2017/0465/P, 6 Highgate Road, NW5  
Variation of Condition 5 of consent 2014/3517/P  
Cass D1 ground floor surgery and upper floor 2 bedroom self-contained maisonette class C3

Further to our telephone conversation regarding the above, I have the following **strong objections** to the proposed variation and other amendments/changes:

USED BUILDINGS APPROX 6 HIGHGATE ROAD

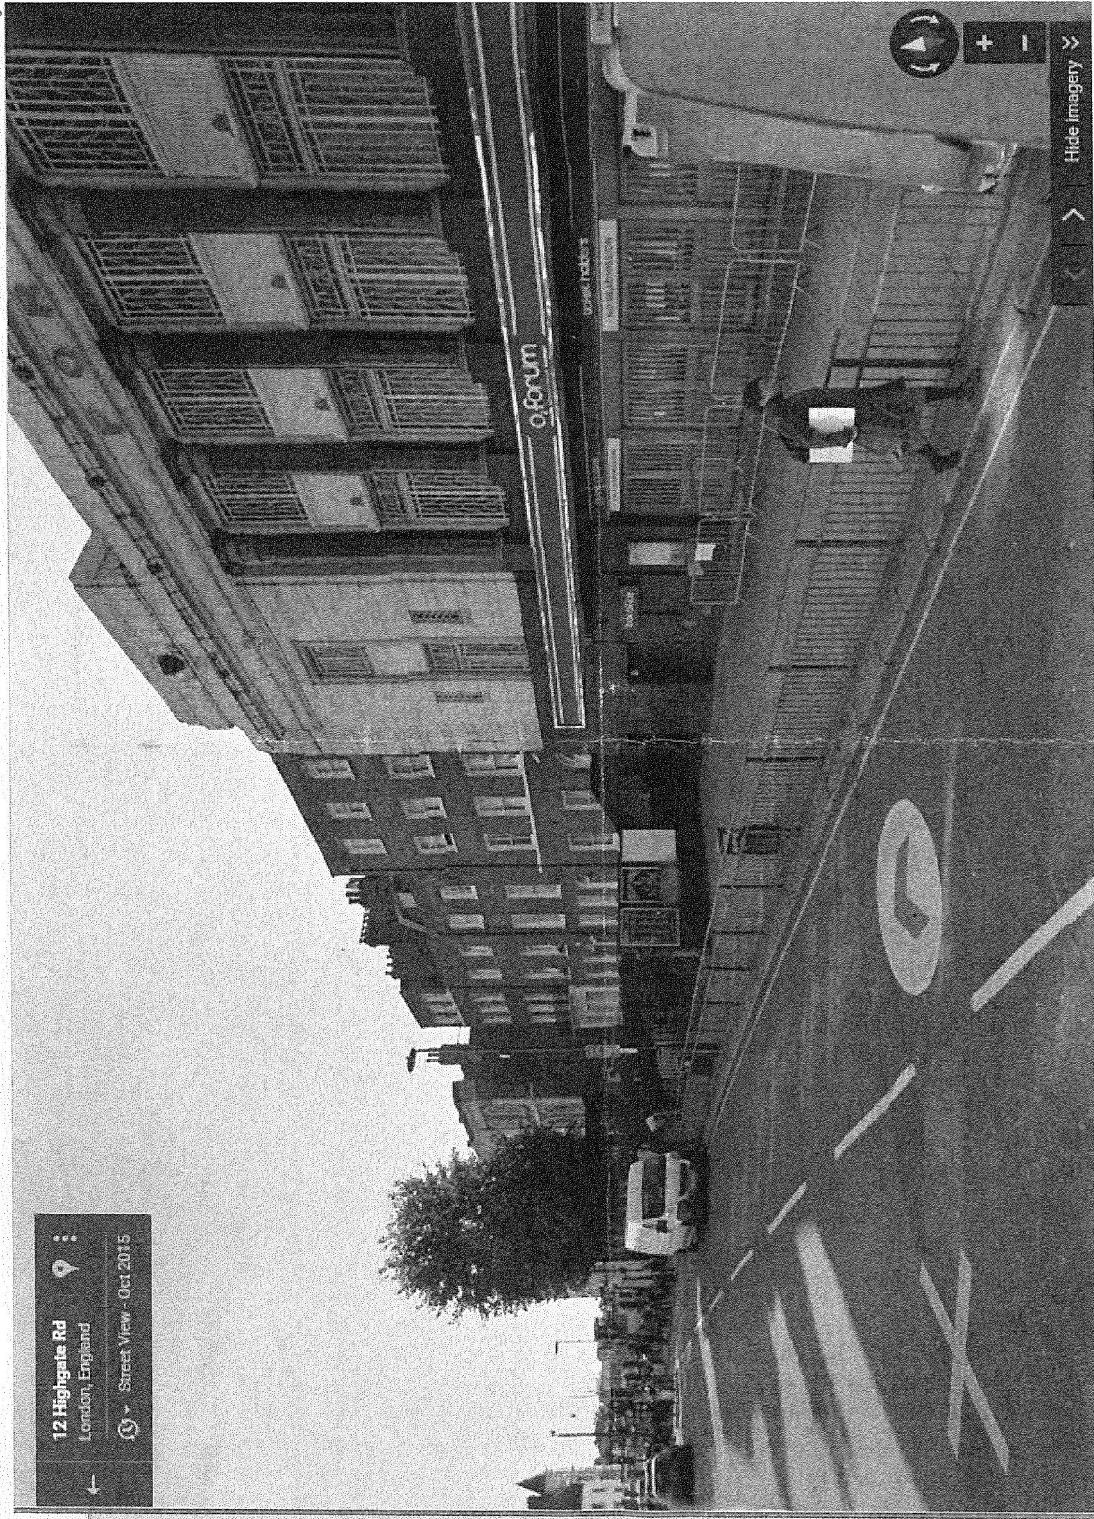
**Refuse/Recycling facility:** The revised first floor plan living accommodation shows a removed dedicated kitchen room, replaced by a kitchen unit-run within the living area. This will seriously compromise space allocation for storage of refuse and recycling. The small cupboard space available for this at ground floor entrance is very small. Adequate storage must be provided for this purposed and be annotated on the drawings. There is a continuous problem regarding the illegal placing of refuse on the pavement at this location and in similar such tight conversions without sufficient external storage space.

The informative 8 (2014/3517/P refers to 'adequate internal and external storage ...'.

There is however, no 'external' space available for this maisonette. Please include a more detailed Informative; eg see those listed in Decision Letter numbered 2, 3 and 4 of 2011/3807/P at 143/145 Highgate Road, to facilitate any future need for enforcement.
